SUBJECT: Petition PB-16-59 SUP. eda engineers-surveyors-planners, Inc., agent for SMLC, LLC, owner. Special use permit with Intermediate development plan review to allow construction of a new mixed use development with a residential density of 25 additional dwelling units per acre over the allowable 100 units per acre. Zoned: UMU-2 (10-100 units/acre and up to 25 additional units/acre by special use permit, urban mixed-use district). Located at 1105 West University Avenue.

SUBJECT: Petition PB-16-59 SUP, eda engineers-surveyors-planners, Inc., agent for SMLC, LLC, owner. Special use permit with Intermediate development plan review to allow construction of a new mixed use development with a residential density of 25 additional dwelling units per acre over the allowable 100 units per acre. Zoned: UMU-2 (10-100 units/acre and up to 25 additional units/acre by special use permit, urban mixed-use district). Located at 1105 West University Avenue.

RECOMMENDATIONS/REQUIREMENTS/COMMENT

C0.00

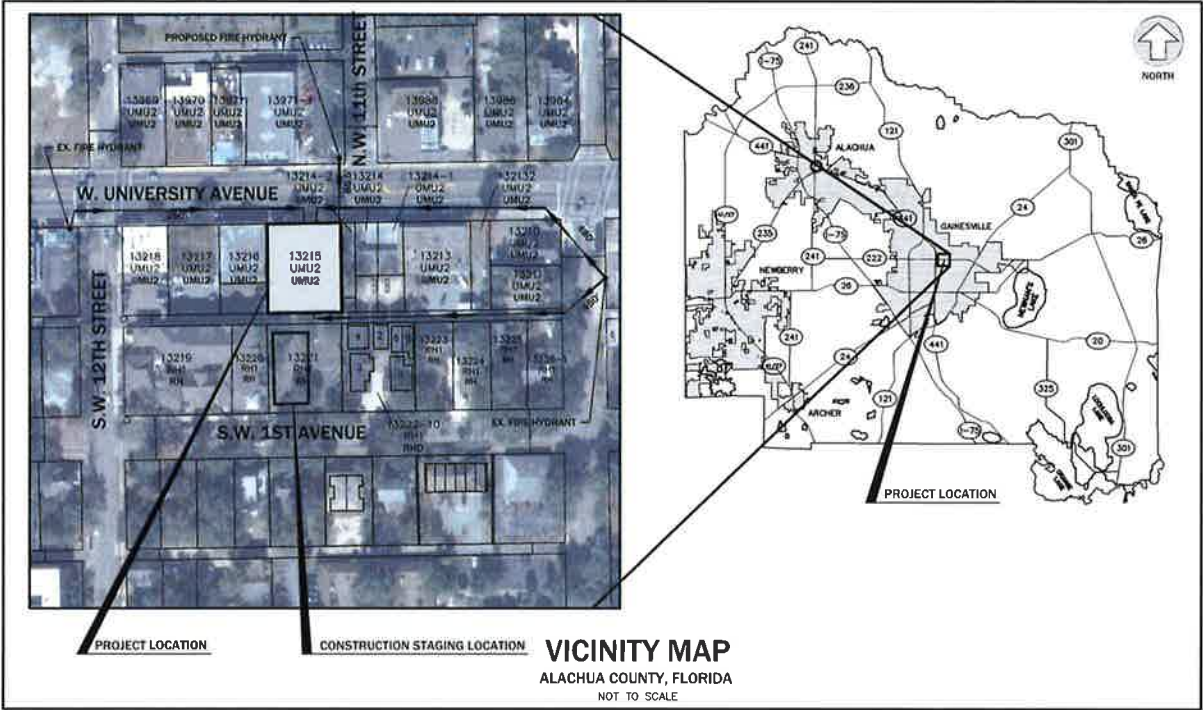
2. Under Specialty Retail in the trip generation table, the 50%/50% trip distribution split for the average daily trip total of 398.4 shows 199.2 and 119.2, when both numbers should be 199.2; please correct.

3. Under "Preliminary net trip generation for proposed project," the average trips total should read 480.9 ($616.9 - 136 = 480.9$). The total listed in the table reads 480.0; please correct.

4. Under "40% reduction in trips allowed by Transportation Mobility Element Policy 10.2.5," the PM Peak line should read $0.40 \times 30.5 = 12.2$, not the $0.40 \times 50.5 = 12.2$ as listed; please correct.

5. Please make the above corrections to the trip generation table on sheet C0.00 and in a revised trip generation memorandum to be provided to attach to the concurrency/TMPA long form.

Response: Please see sheet C0.00 of the revised plan set for revised trip generation.

Response: The PM peak factor has been adjusted on sheet C0.00 of the revised plan set. Retail tenant has not been determined at this time so the AM trip generation remains in the plans.

Response: Please see sheet C0.00 of the revised plan set for the recalculated net impact numbers.

C1.00

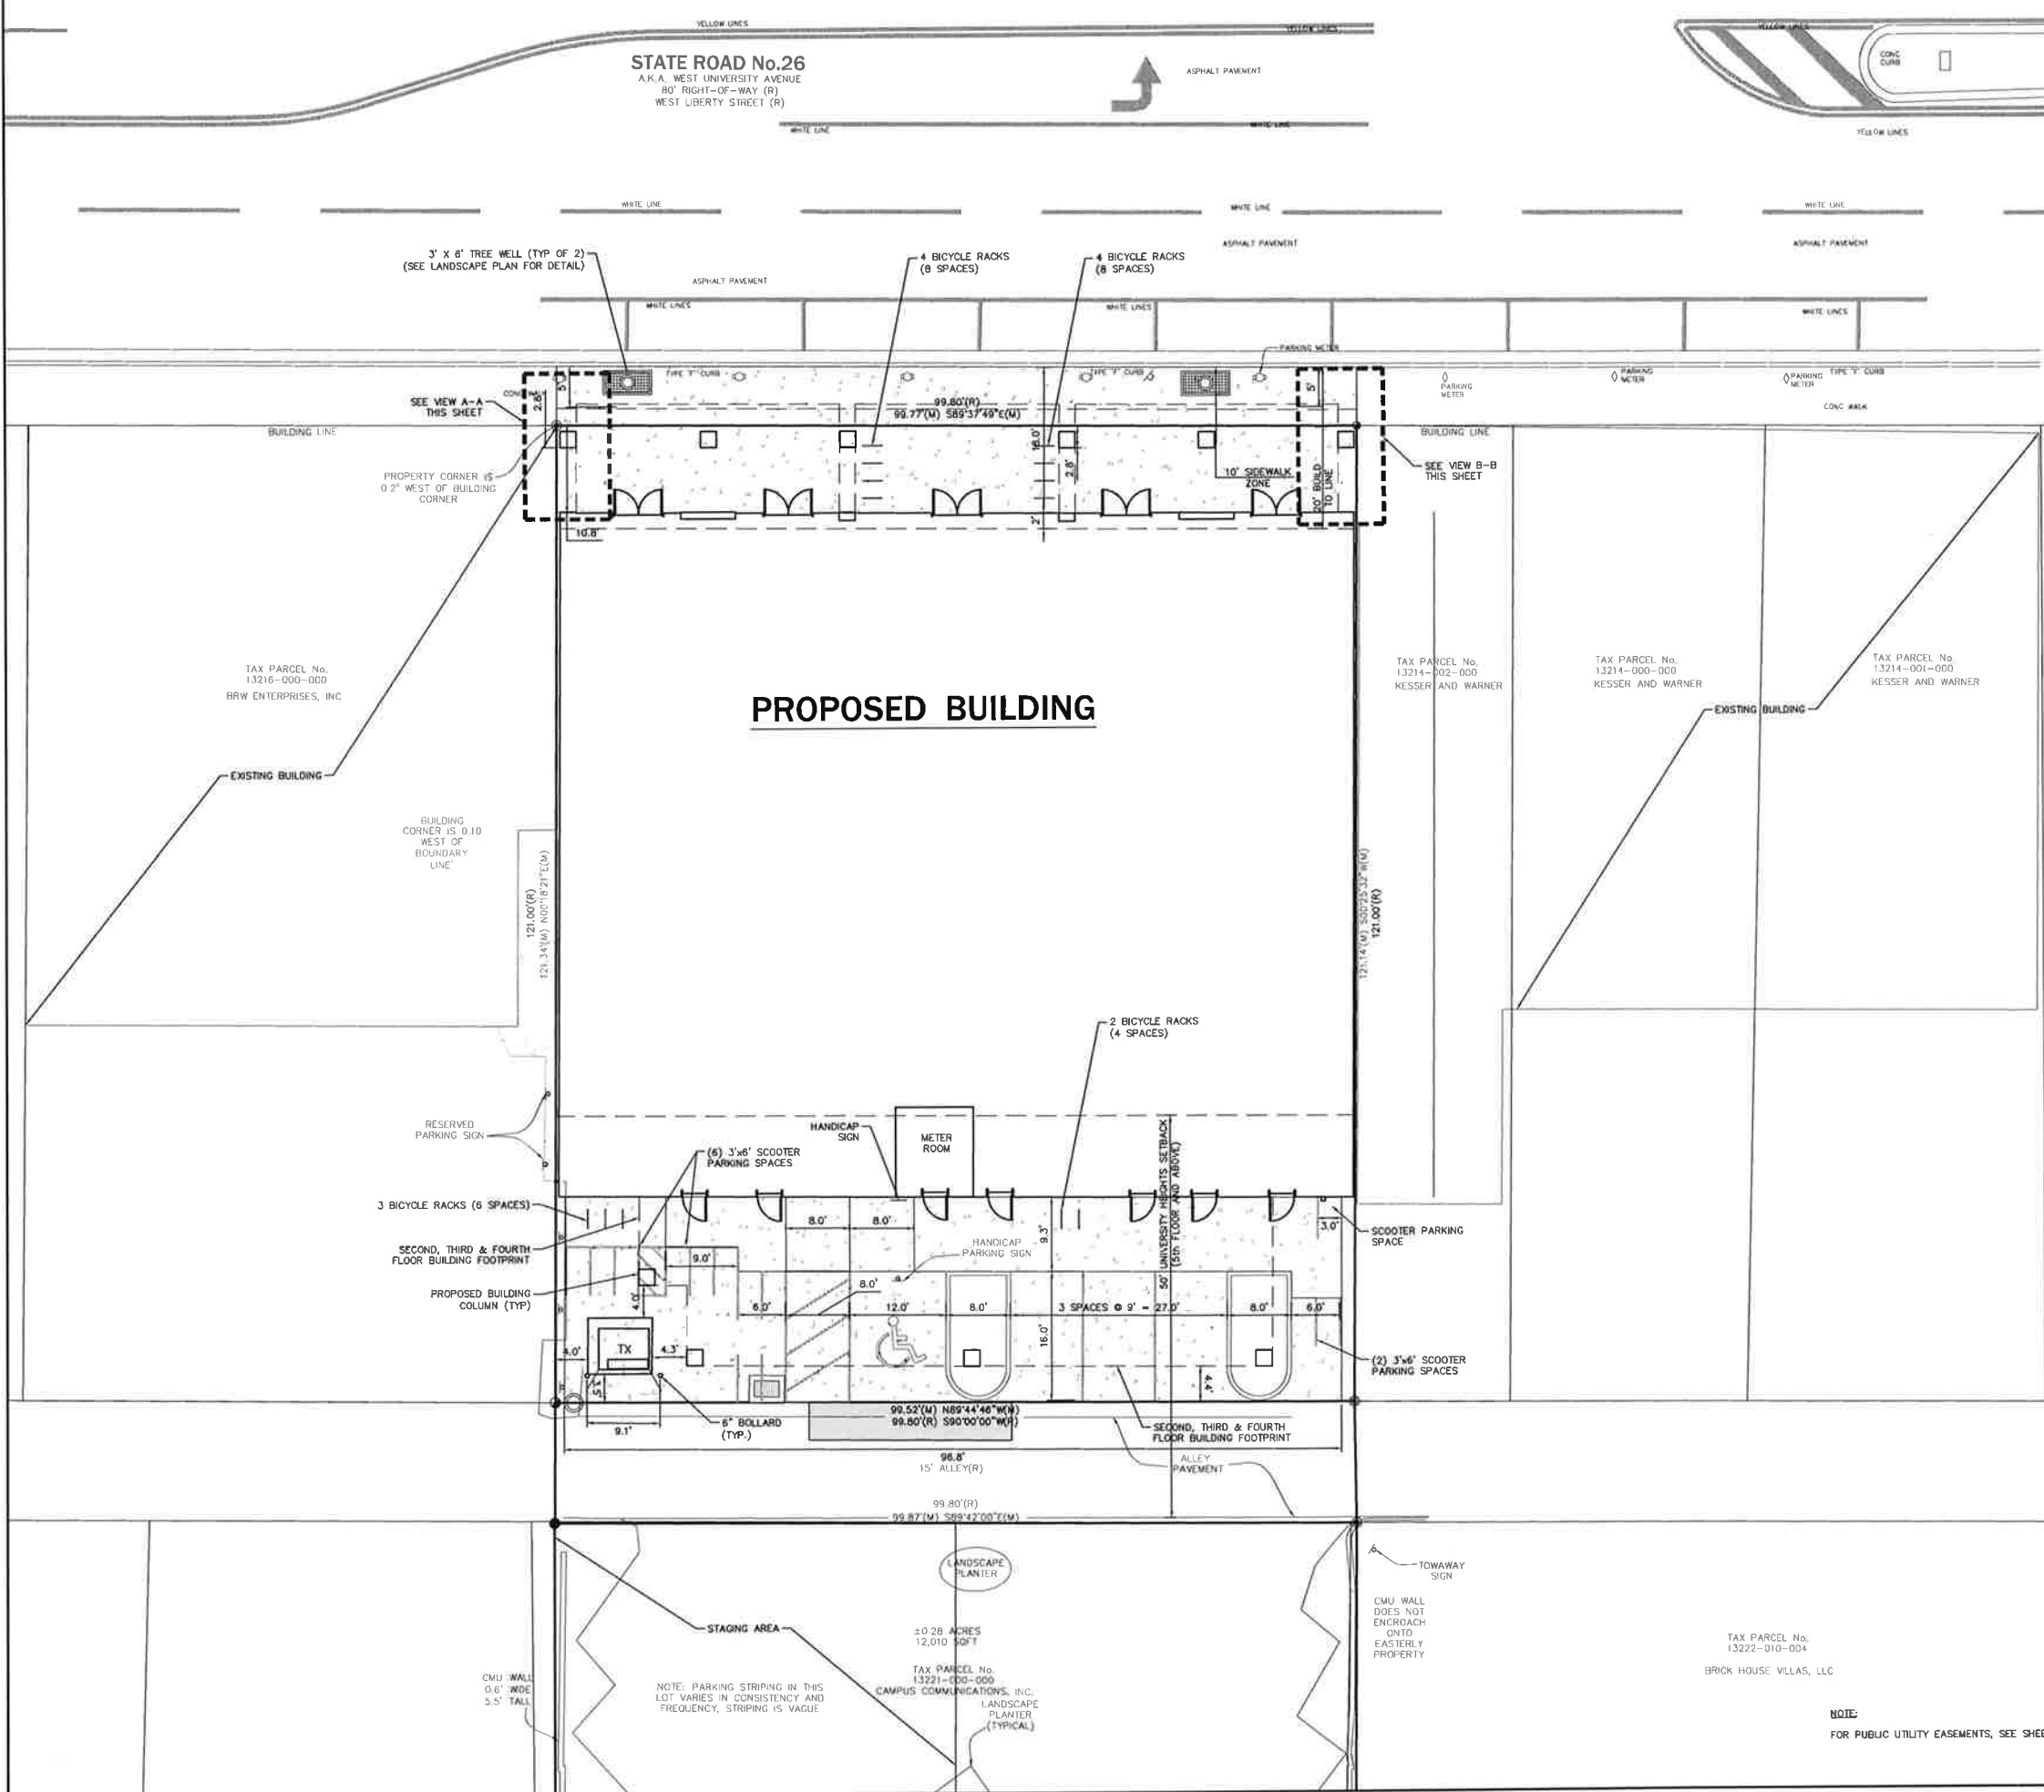
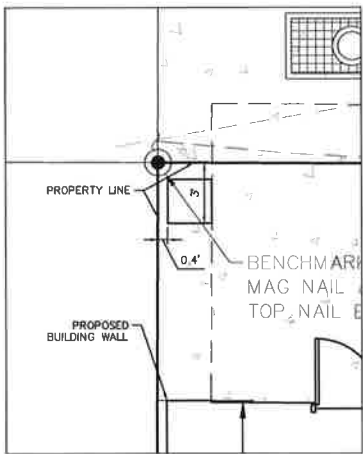
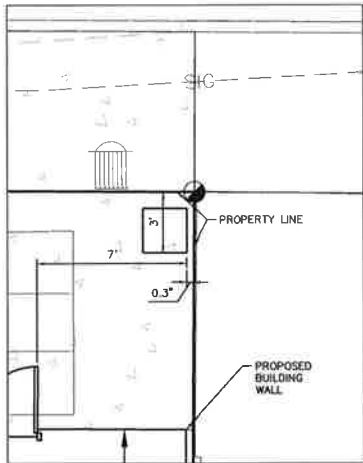
- ~~5. The development also contains door swings onto the provided 10-foot sidewalk; please correct; this design is not acceptable. If the sidewalk is provided on private property, proper easements are required.~~

9. The UMU-2 requires a build-to line of 20 feet with a 10 foot wide sidewalk and a 5 foot wide landscape zone. The proposed design does not meet this requirement; no landscape zone is provided, the build-to line is 8 feet from back of curb and sidewalk provide is only 7 feet wide within the public right-of way with two street trees. The applicant must request and obtain waivers from the board in order to proceed with the proposed design.

Response: The tree wells have been relocated to provide 5 feet of unobstructed sidewalk width. See sheet C1.00.

Response: The doors have been pulled in 1' to not swing into the right-of-way. See sheet A2.01 and C1.00.
